Rider 100 TRANSMITTER
ID Reader Rev 6C
Honor Design, Inc
Feb 3, 1998
updated 2/24/1999

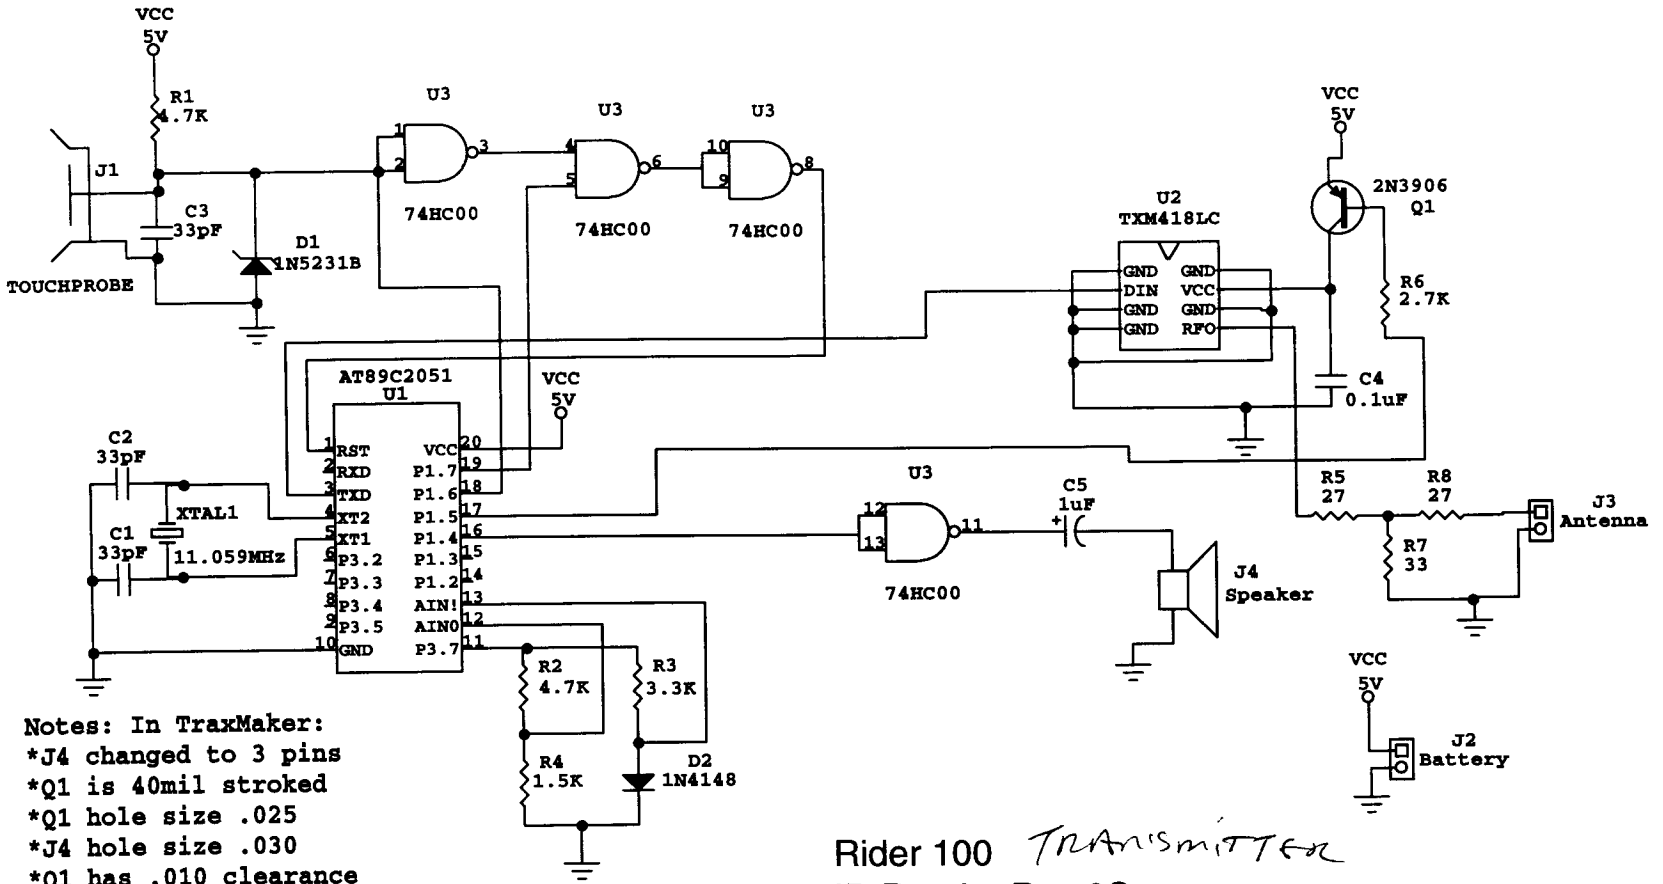
Notes: In TraxMaker:
*J4 changed to 3 pins
*Q1 is 40mil stroked
*Q1 hole size .025
*J4 hole size .030
*Q1 has .010 clearance
*hole sizes to .028 &
.035 for AP circuits
